# Technical Service Information

## FORD 6F35

### TRANSMISSION CASE DAMAGE

Figure 1

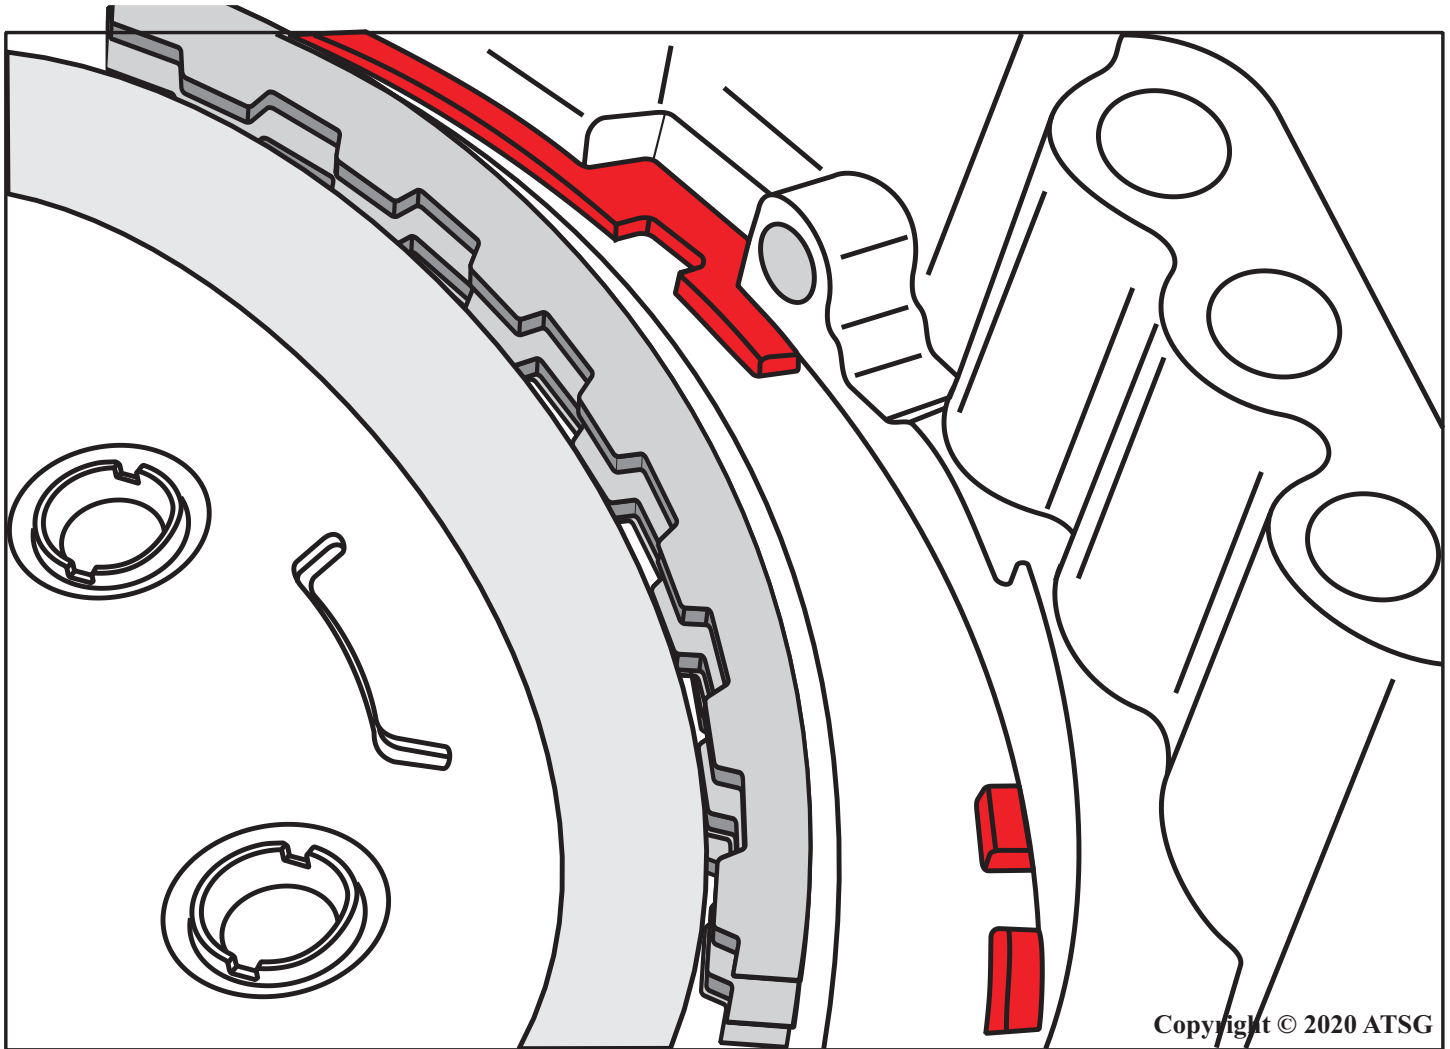
**COMPLAINT:** A 2013 Ford vehicle with a 6F35 Transmission comes into the shop for an internal transmission related problem. Upon disassembly, once the 1-2-3-4 clutch retaining snap ring is reached, the technician notices several case lugs have broken away from the transmission case.

**CAUSE:** The 1-2-3-4 clutch retaining snap ring gap was installed incorrectly. Also noticed is the fact that the snap ring gap has not been installed in its correct location. Although this mistake can be made on the bench by a technician that is not aware of how it should be installed, this transmission has never been repaired until now meaning this was mistakenly done at the factory during the assembly process.

**CORRECTION:** The snap ring gap must be installed at the three o'clock position with the bottom of the transmission facing the six o'clock position as shown in figure 1. If one or two lugs are broken out, just install the snap ring gap in its correct position. If too many lugs are broken out, the transmission case will require replacement. This seems to be a problem isolated to the 2013 model year as far as only the factory mistake goes.
